CITY OF ALBUQUERQUE

**Re: Taco Bell @ McMahon Marketplace
10600 Unser Blvd. NW
Request 30-Day Temporary C.O. - Accepted
Engineer's Stamp dated: 6-17-15 (A11D011D)
Certification dated: 6-14-17**

AS-BUILT GRADING & DRAINAGE PLAN

C2.0

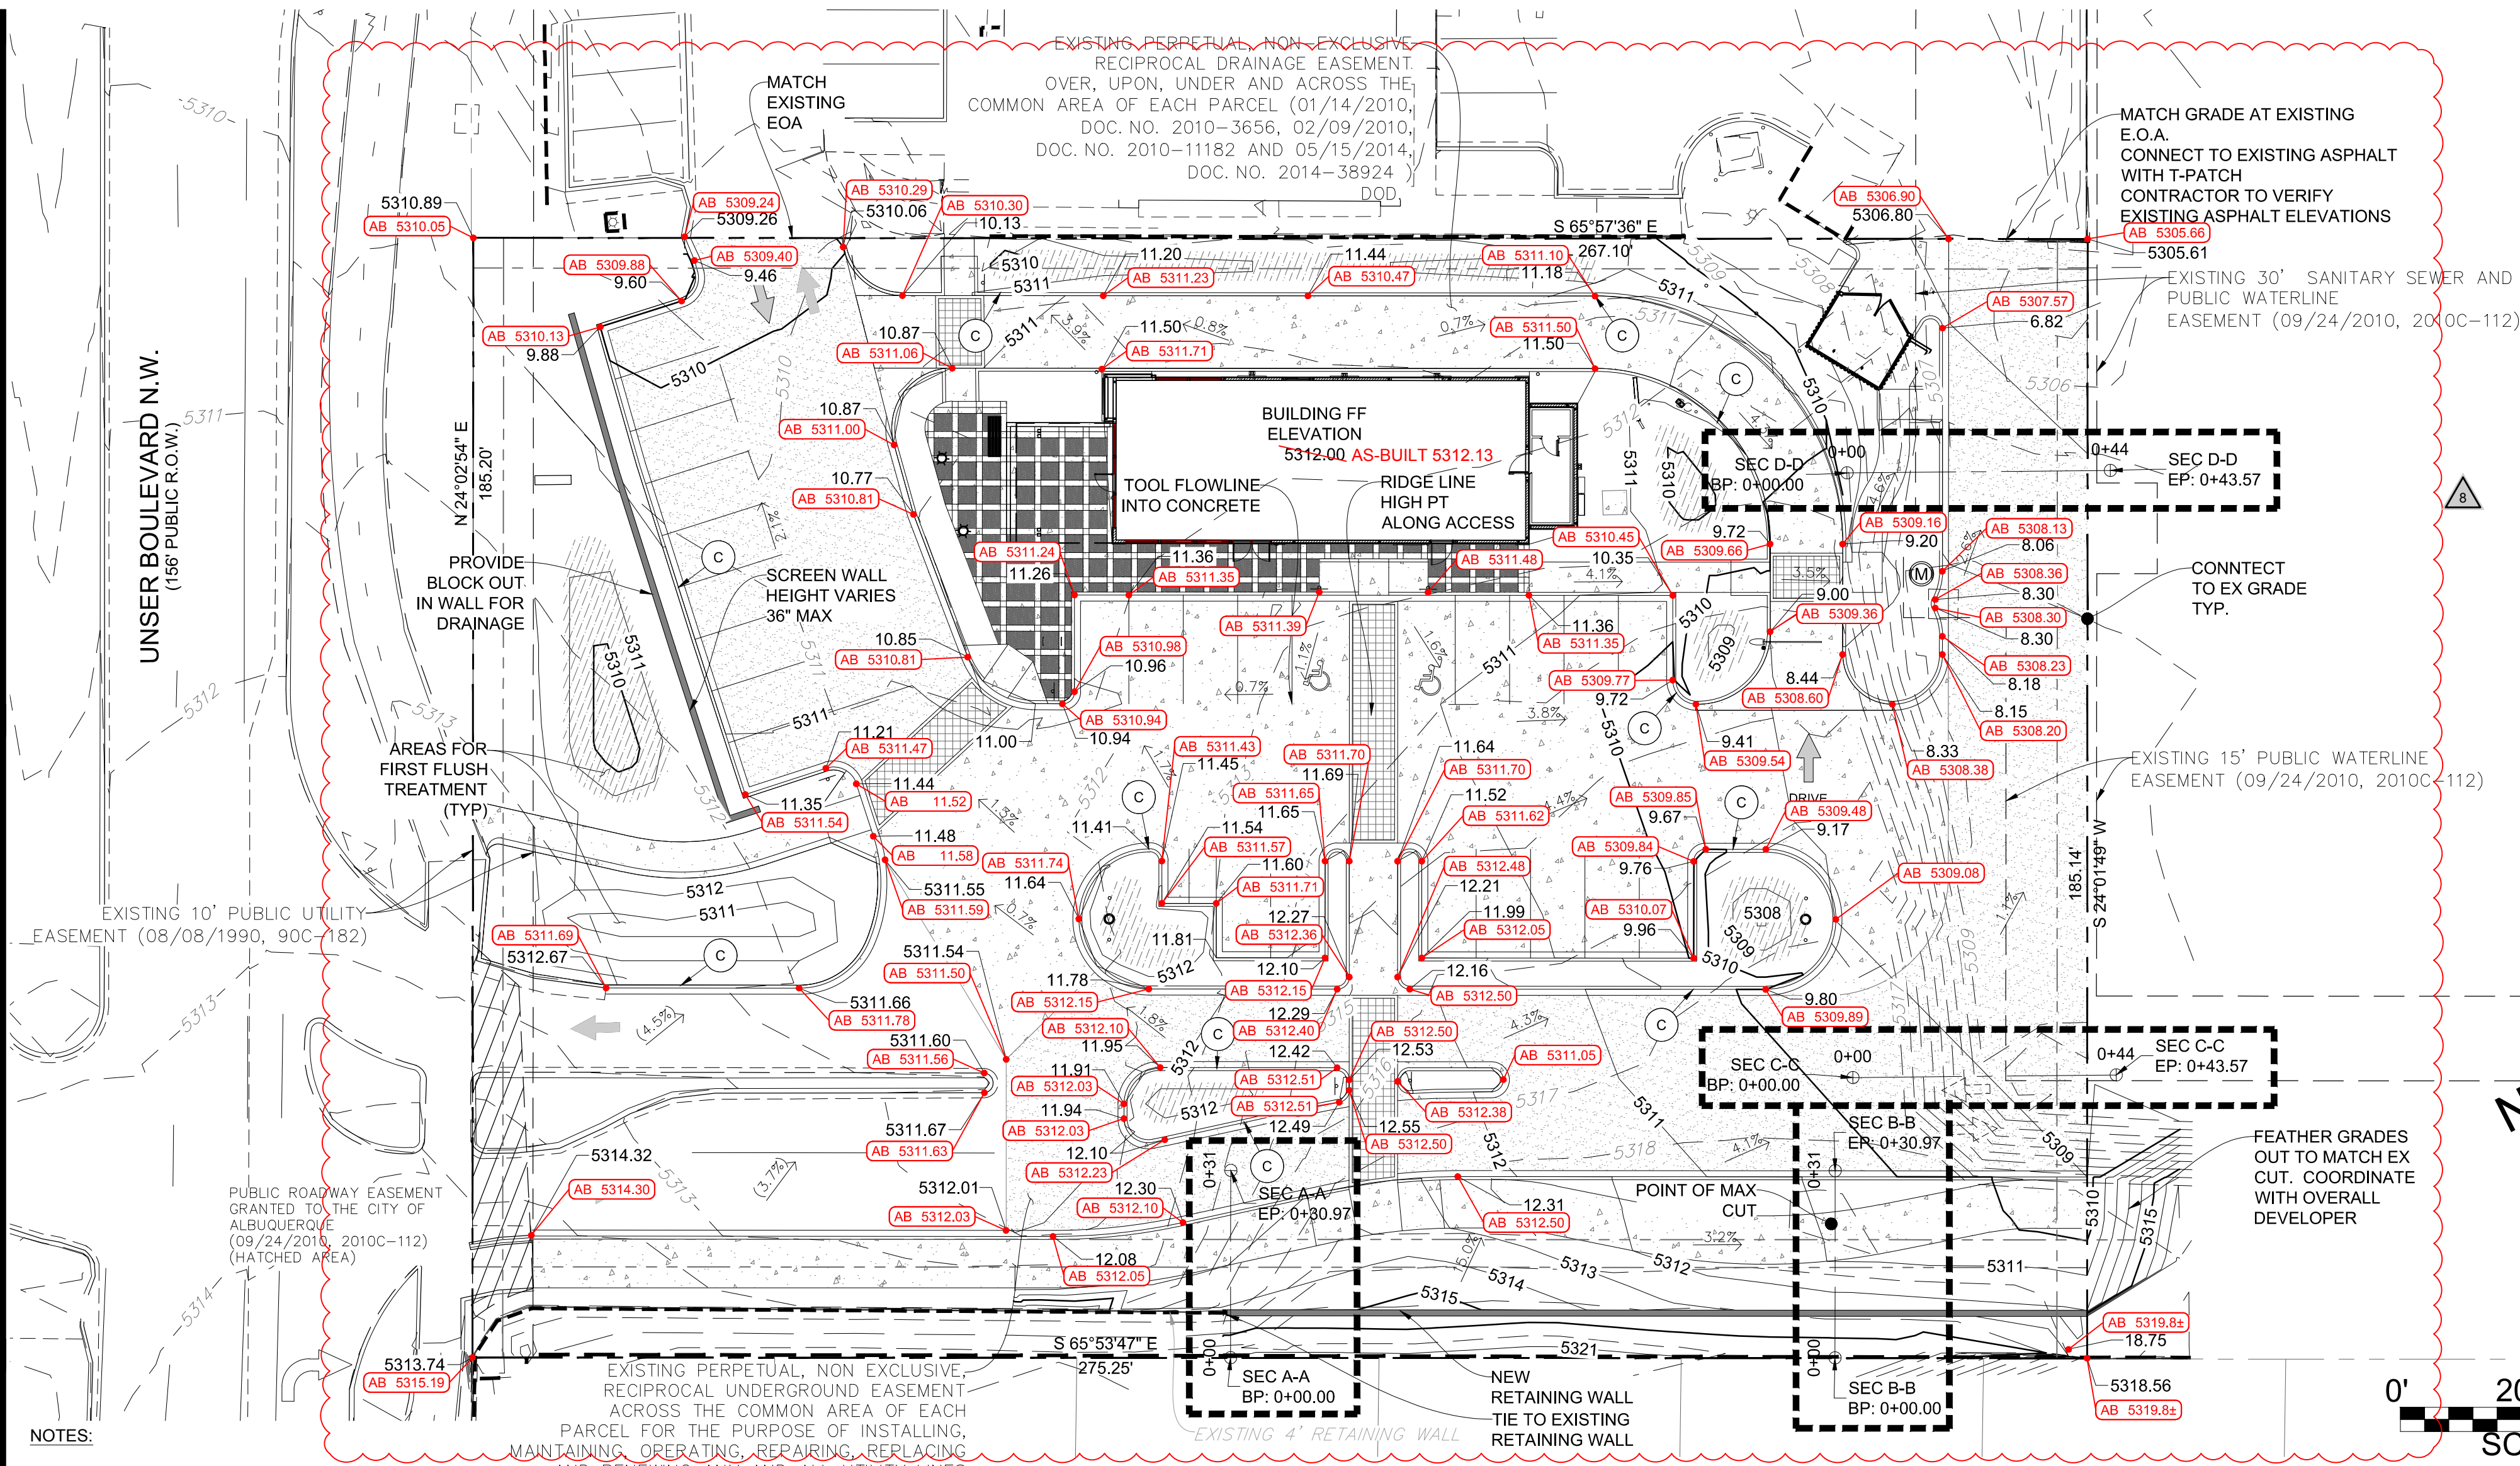
Based on the Certification received 6/14/2017, Hydrology has no objection to the issuance of a 30-day Temporary Certification of Occupancy based solely on the Hydrology Certification received from Lance P. Vandemark, PE. This letter serves as a "green tag" from Hydrology for a 30-day Temporary Certificate of Occupancy to be issued by the Building and Safety Division. The above referenced site cannot be accepted for release of Certificate of Occupancy by Hydrology until the following comments are addressed:

- Provide as-built information that addresses all comments on approval letter with engineer stamp date of 9-8-16.
